# Access Compliance Report

## Public Rights-of-Way

Intersection ID: 15523	Main Street: ORANGE_ST	Cross Street: SAM_DRENAN_RD	Location:	N
ADA ID: 3F55A5586DEA	Ramp Type: Perp	Initial Pass/Fail: Fail	Overall Compliance: No	Severity Score: 37.5
Codes/Mitigation Info/Possible Solution		Field Measurements/Component Compliance

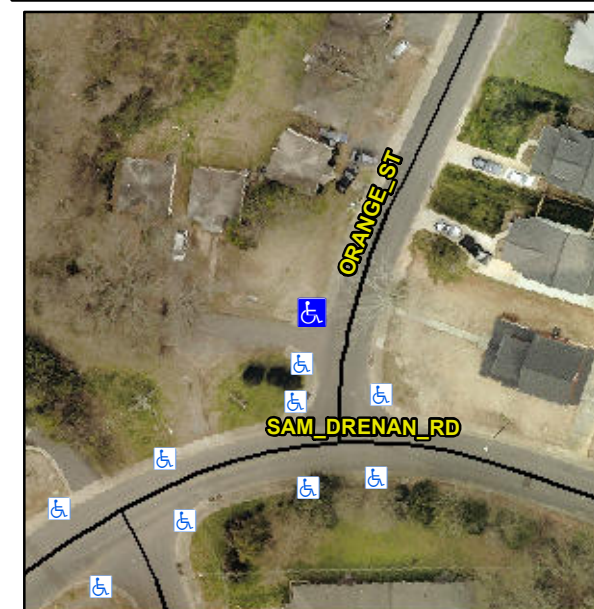
**Not Found, R304.2.2, R304.5.3**

Compliance	Description	Data	Compliance	Description	Data
N/A	Ramp Length (in)	48.0	No	Ramp Slope (%)	11.9
Yes	Ramp Width (in)	48.0	No	Ramp XSlope (%)	9.9
N/A	Flare Type LT	N/A	N/A	Flare Type RT	N/A
N/A	Flare Slope LT (%)	N/A	N/A	Flare Slope RT (%)	N/A
N/A	Flare Traversable LT?	N/A	N/A	Flare Traversable RT?	N/A
N/A	Landing Length (in)	N/A	N/A	DWS Provided?	N/A
N/A	Landing Width (in)	N/A	N/A	DWS Contrast?	N/A
N/A	Landing Slope (%)	N/A	N/A	DWS Length (in)	N/A
N/A	Landing X Slope (%)	N/A	N/A	DWS Full Width?	N/A
N/A	Landing Curb? (Y/N)	N/A	N/A	DWS Offset (in)	N/A
N/A	Shared Landing?	N/A			
N/A	Gutter Ponding?	N/A	N/A	Gutter Slope (%)	N/A
N/A	Gutter Lip Ht (in)	N/A	N/A	Gutter X Slope (%)	N/A
N/A	Painted X Walk1?	No	N/A	Painted X Walk2?	N/A
	X Walk 1 Direction	To SW		X Walk 2 Direction	N/A
N/A	X Walk 1 Width (in)	N/A	N/A	X Walk 2 Width (in)	N/A
	X Walk 1 Slope (%)	5.6		X Walk 2 Slope (%)	N/A
	X Walk 1 X Slope (%)	4.7		X Walk 2 X Slope (%)	N/A

**Remove & Replace Entire Ramp.**
